Addendum No. 1

Rock River Water Reclamation District Clarifier Railings (Primary Clarifier Tanks 1-4 & Parshall Flume) Capital Project No. 1706

This Addendum Number 1, dated September 13, 2018, for the above referenced project, supersedes all contrary and conflicting information in the specifications and contract documents, which are hereby supplemented or revised as follows:

LEGEND, GENERAL NOTES, & SUM OF QTYS

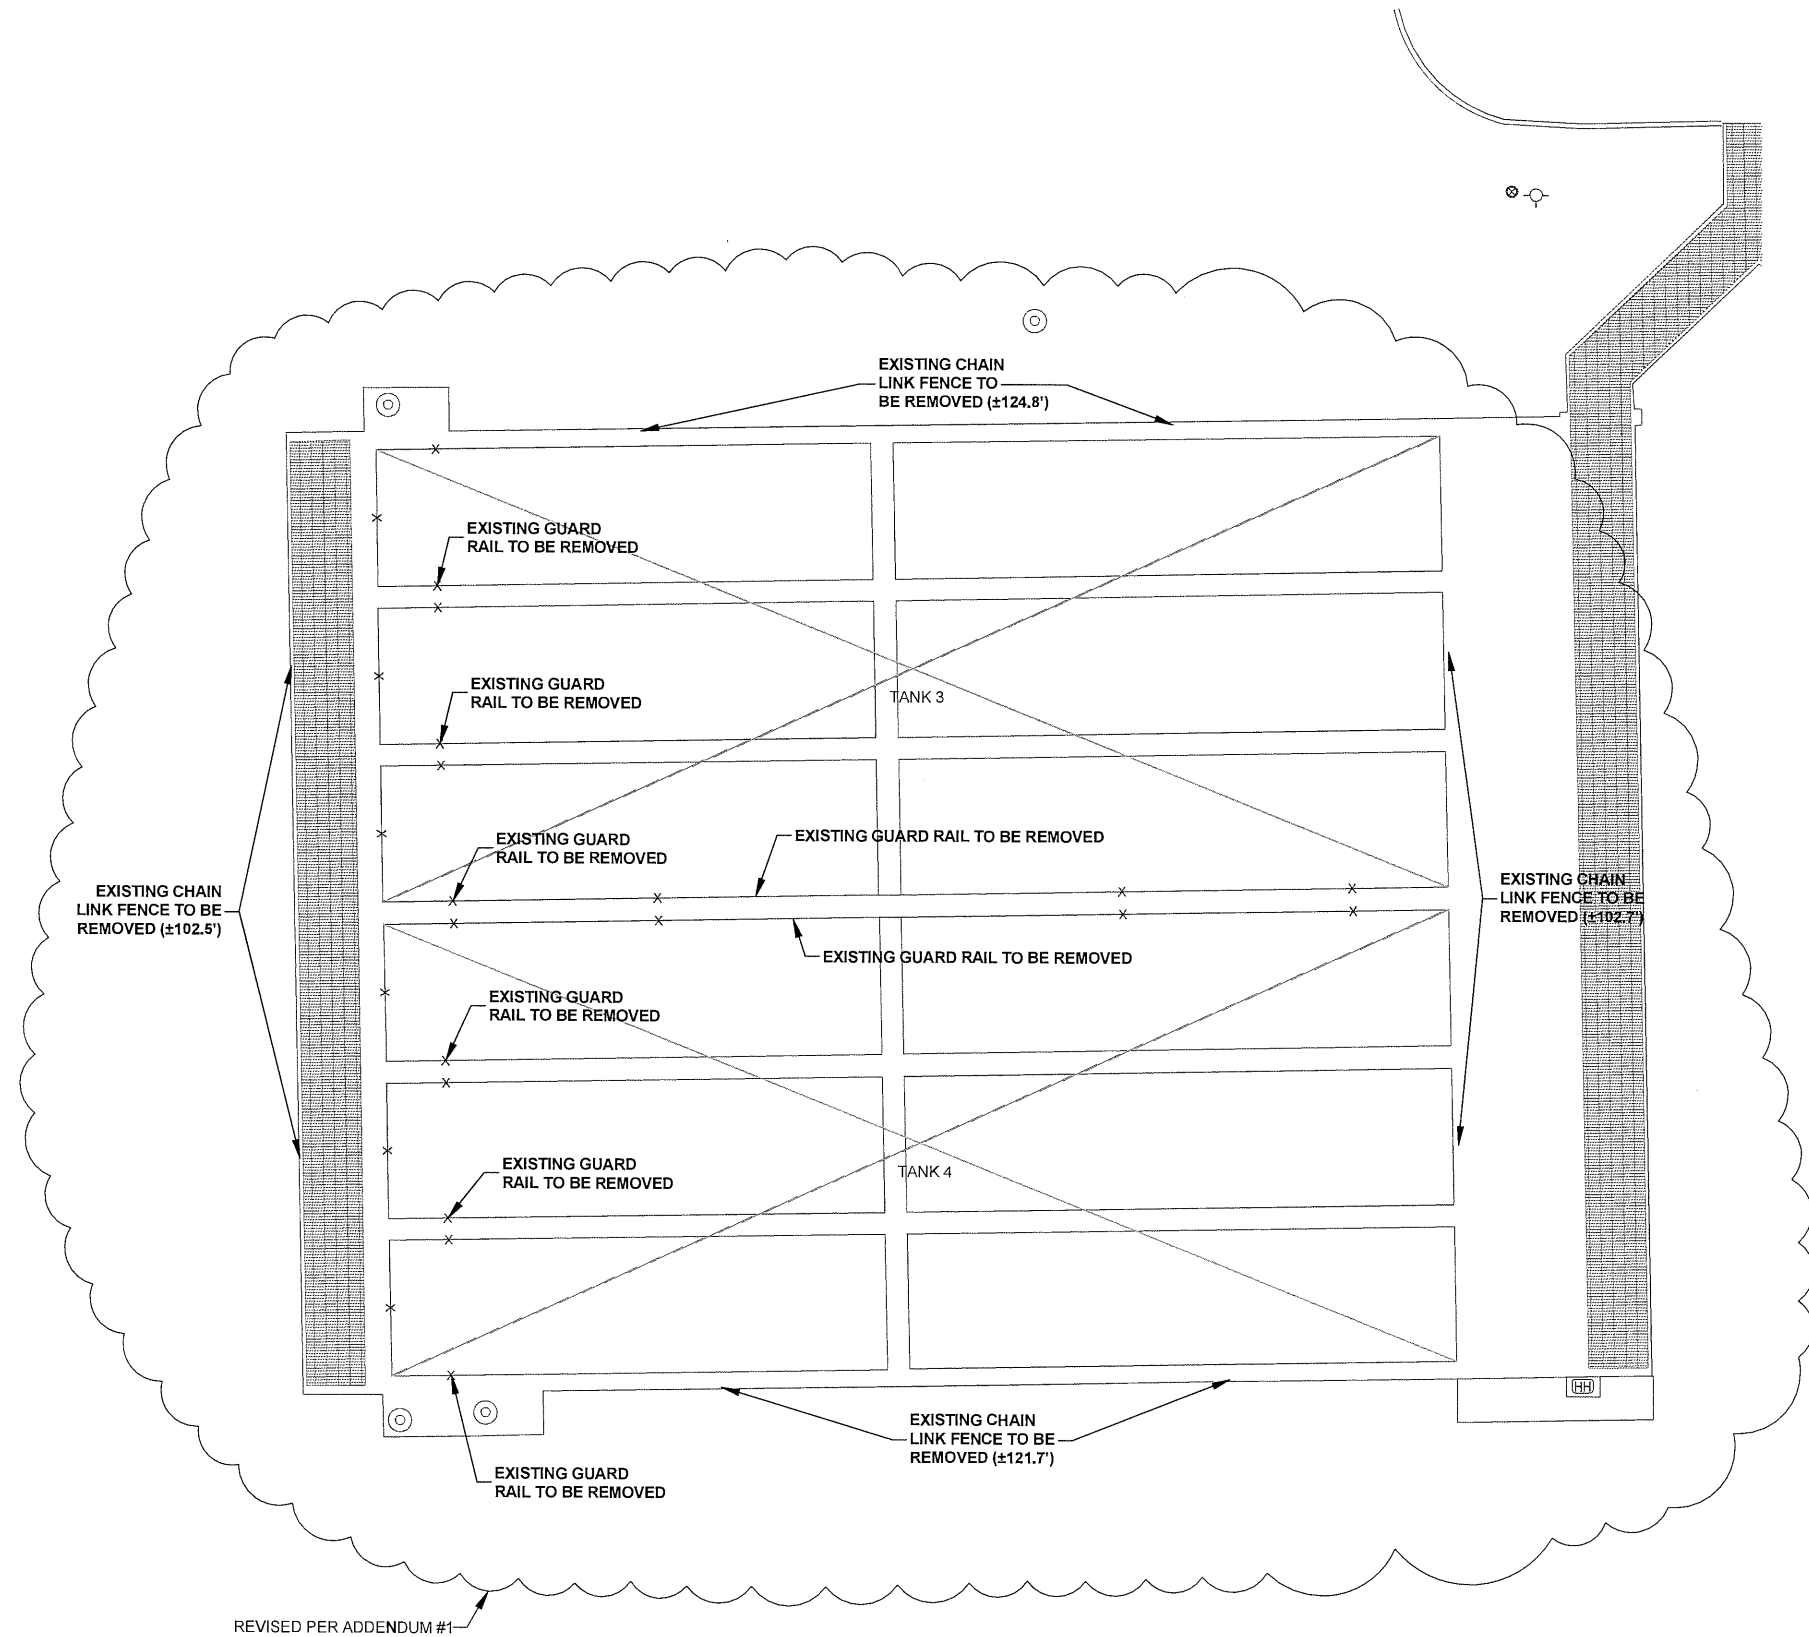
1. The following plan sheets have been revised. Revised plan sheets are attached and shall replace original plan sheets:
 - a. Sheet 2/10 – LEGEND, GENERAL NOTES, & SUMMARY OF QUANTITIES: Summary of Quantities has been updated to reflect the revisions to the 1-1/2" DIA. ALUMINUM PIPE RAILING WITH 4' TOE PLATE, COMPLETE pay item and the addition of the REMOVAL AND RELOCATION OF EXISTING GUARDRAIL SYSTEM, COMPLETE.
 - b. Sheet 3/10 – Plan view has been updated to reflect the additional existing guard rail and toe plate to be removed.

CLARIFIERS 1 & 2 - EXISTING CONDITIONS & DEMO

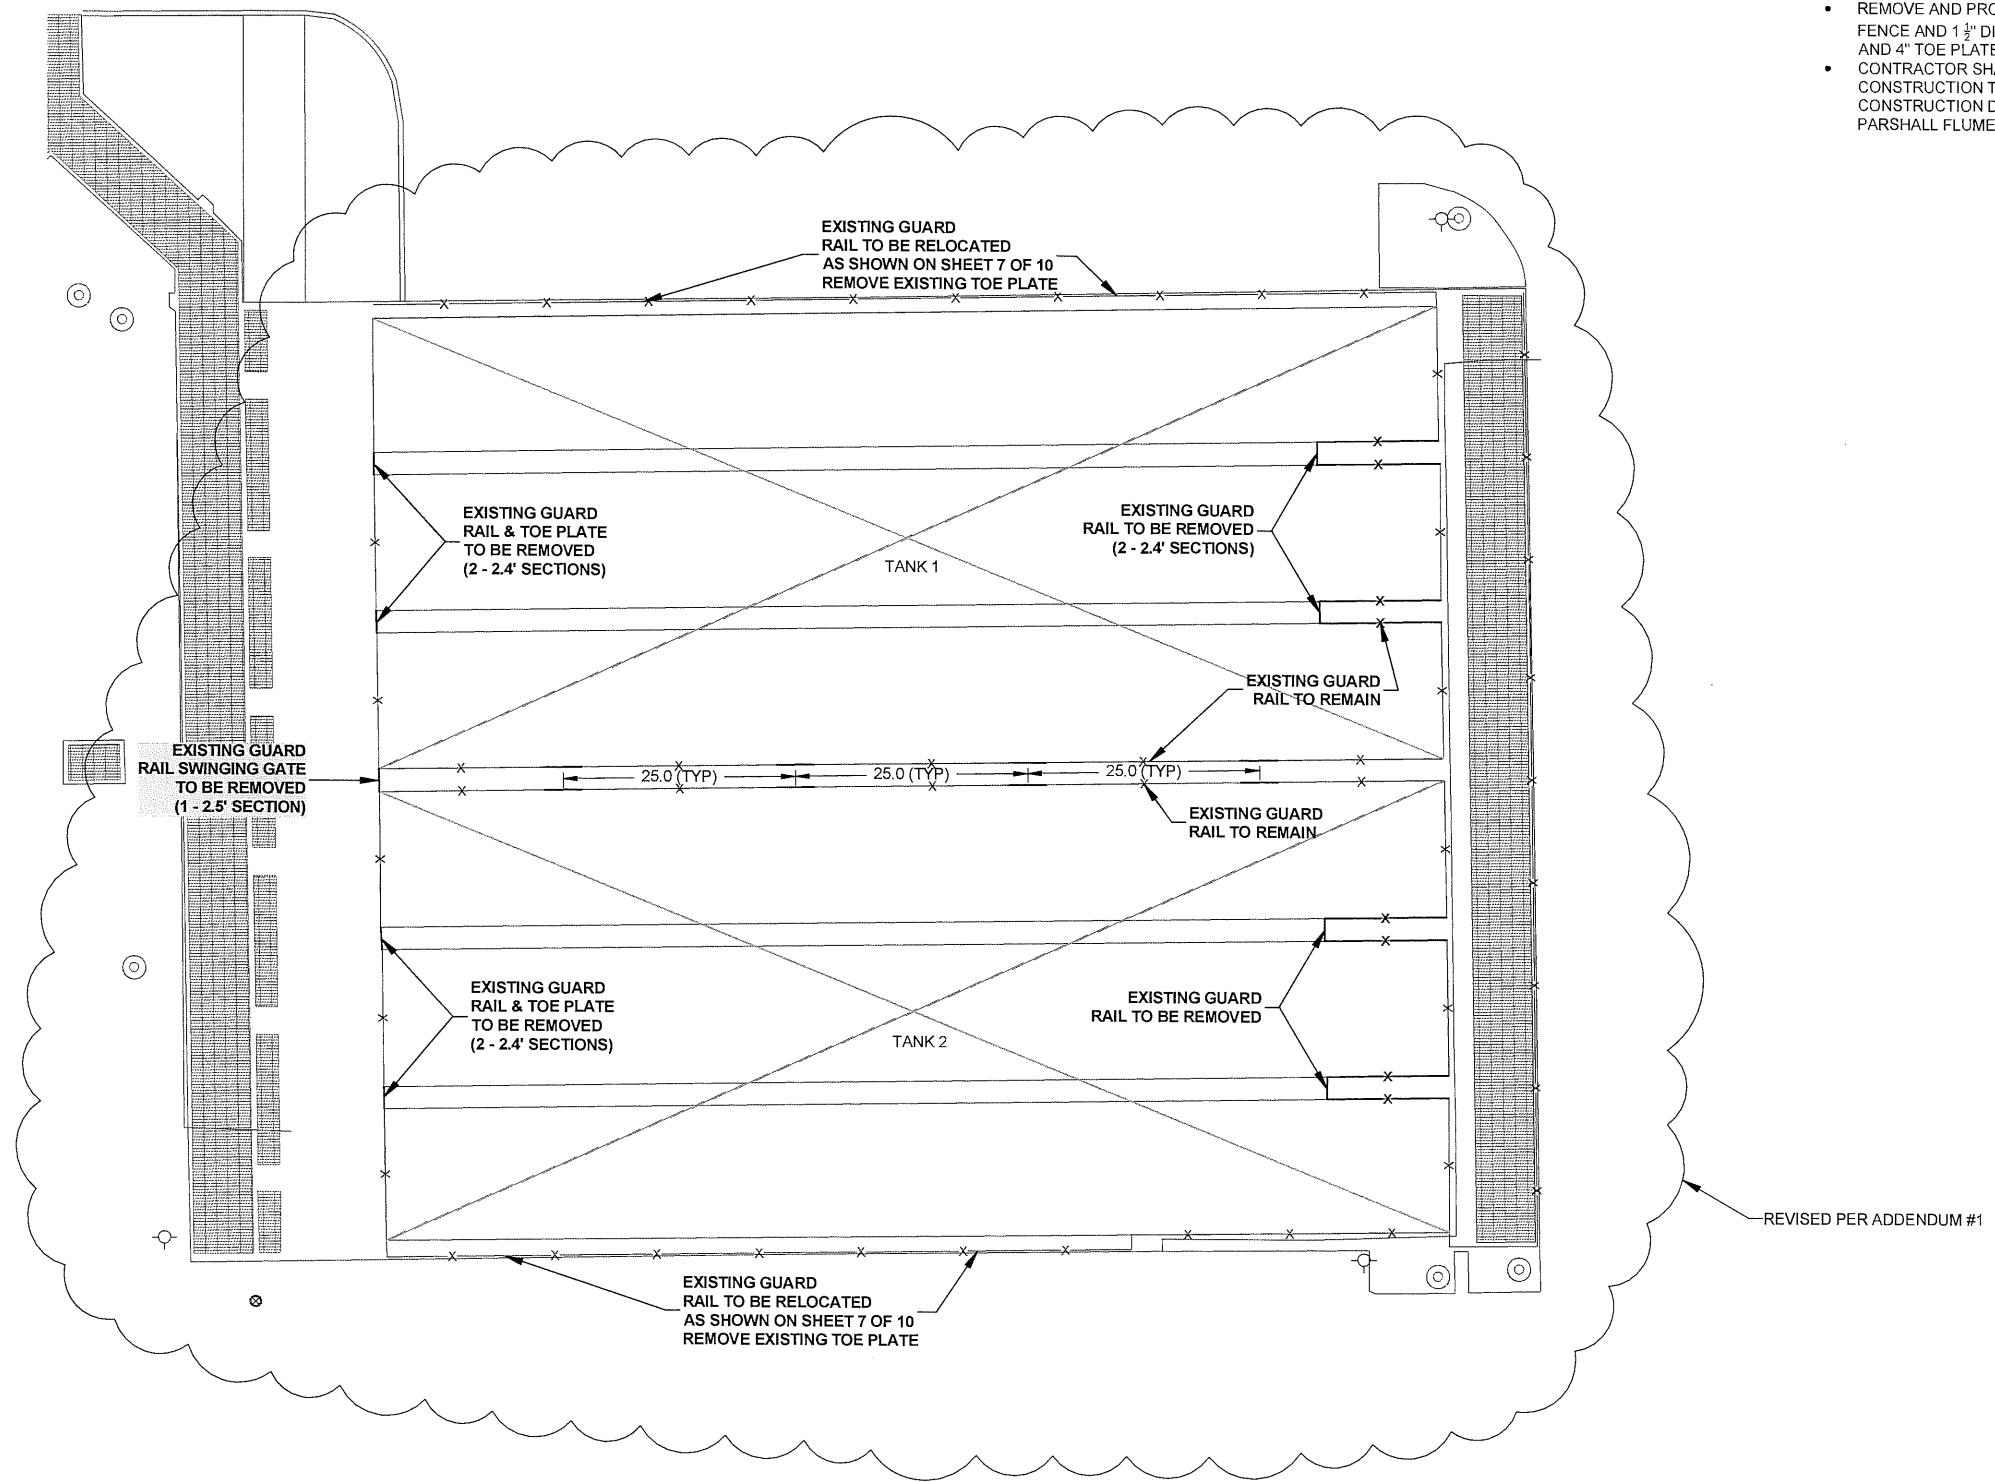
- c. Sheet 4/10 –Plan view has been updated to reflect the additional existing guard rail and toe plate to be removed and existing guard rail to be removed and relocated.
- d. Sheet 6/10 –Plan view has been updated to reflect the additional proposed guard rail and toe plate to be furnished and installed.
- e. Sheet 7/10–Plan view has been updated to reflect the additional proposed guard rail and toe plate to be furnished and installed and existing guard rail to be removed and relocated.
